Intel[®] Pentium[®] III Xeon[™] Processor Specification Update

Release Date: March 2001

Order Number: 244460-026

The Pentium[®] III Xeon processor may contain design defects or errors known as errata that may cause the product to deviate from published specifications. Current characterized errata are documented in this Specification Update.

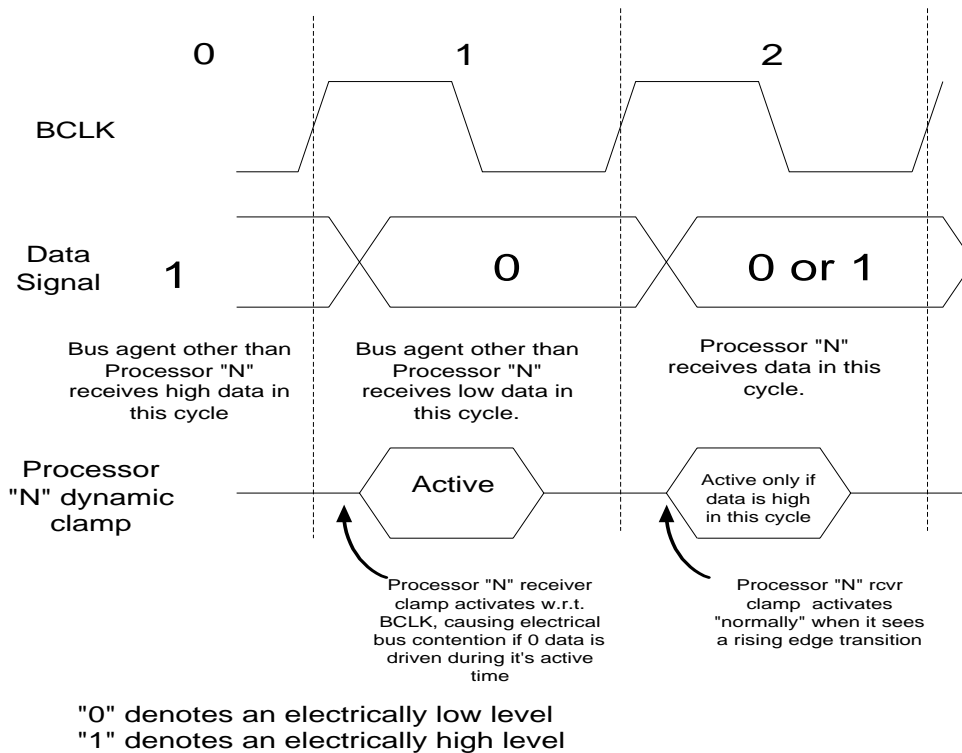
Workaround: The AGTL+ V_{REF} (input voltage reference) level will be raised from 1.0V to 1.1V (assuming a V_{TT} of 1.5V) on the processor cartridge substrate. This allows the dynamic clamp to activate at a trigger level approximately 100 mV higher than with the previous 1.0V V_{REF} setting. Due to the dependence upon system bus design, bus layout may be evaluated to determine the need for improvements in falling edge ringback levels. This may involve one or several of the following baseboard modifications:

1. Change termination resistor value to reduce multi-bit noise and/or improve V_{IL} noise margin.
2. Reduce multi-bit noise by improving ground return paths (additional high-frequency decoupling, improved AC plane referencing, etc.).
3. Raising or lowering the V_{TT} level (within the AC & DC tolerances specified in the processor EMTS) to improve V_{IL} noise margin and/or reduce the multi-bit noise due to dl/dt transients.

Stress tests using various data patterns and transactions should be run to identify the worst-case multi-bit noise conditions for this erratum.
